DESIGN & ACCESS STATEMENT

PLANNING APPLICATION AND LISTED BUILDING CONSENT FOR INTERNAL ALTERATIONS TO FORM TWO NEW SELF-CONTAINED STUDIO UNITS AT SECOND AND THIRD FLOOR LEVEL, INCLUDING LOCALISED REPAIRS TO THE EXISTING SLATE ROOF.

34 GLOUCESTER CRESCENT, LONDON, NW1 7DL

JANUARY 2019

WORK ASSUMED TO CONVERT 2ND & 3RD FLOOR INTO TWO SELF-CONTAINED FLATS.
19-12-18

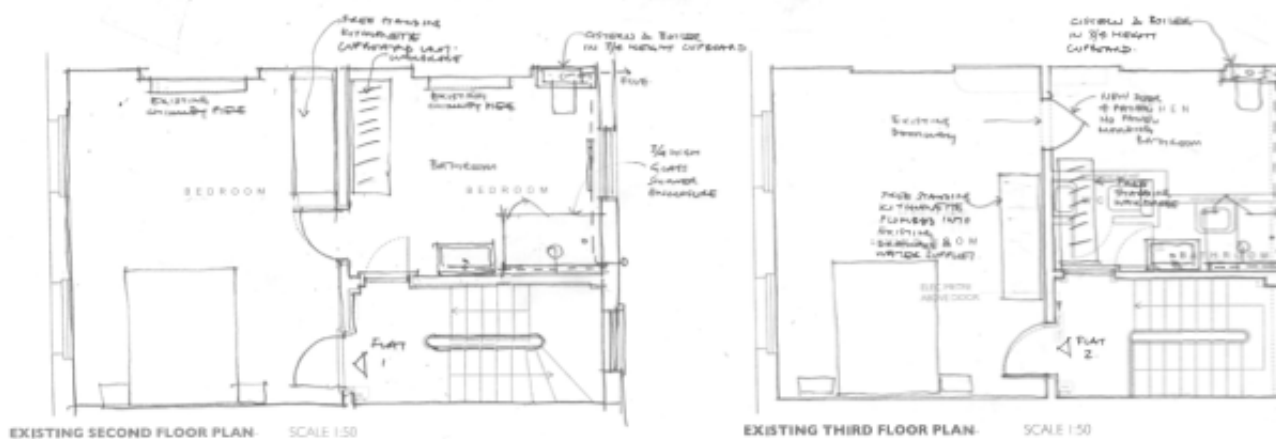
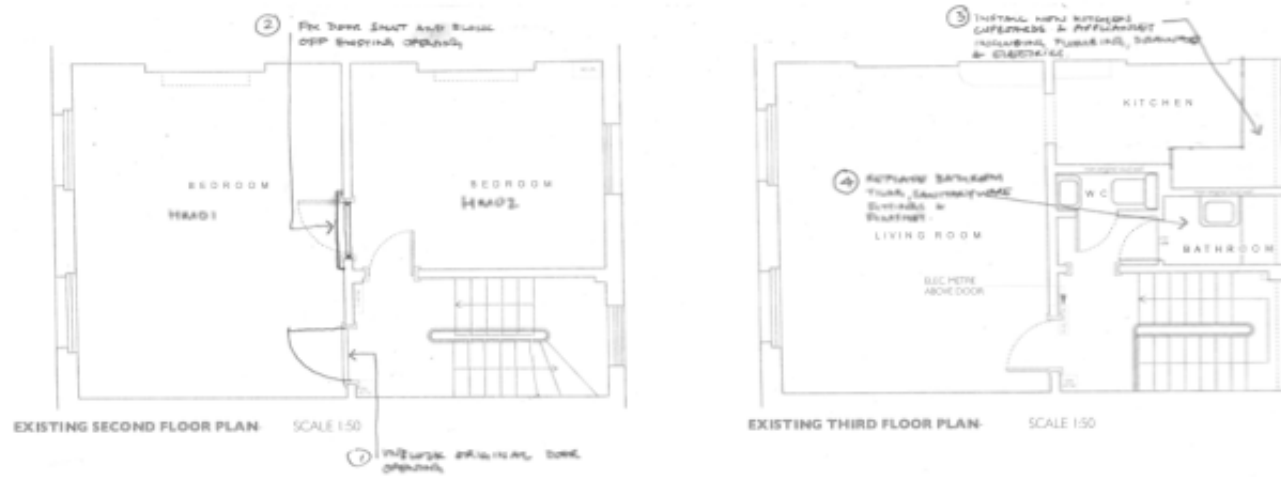
Thank you for the updated plans and the below. I've reviewed with Catherine and we agree that the revised layout for both floors are definitely an improvement which we can accept subject to formal scaled drawings.

On the second floor, this is on the basis that the alcove cupboards are retained (as appears on the drawings). It would be desirable if you reinstate the former wider rear sash window on the third floor.

1. IMPROVE ORIGINAL DOOR OPENINGS TO ALLOW ACCESS OFF COMMON FRANTS PER HEAD
2. Fix door shut & block off structure opening between HEAD 1 & HEAD 2 FOR PRIVACY BETWEEN HEAD ROOMS.
3. INTERNAL VIEW

WORK REQUIRED TO RETAIN EXISTING USE
(2-HRM UNITS)
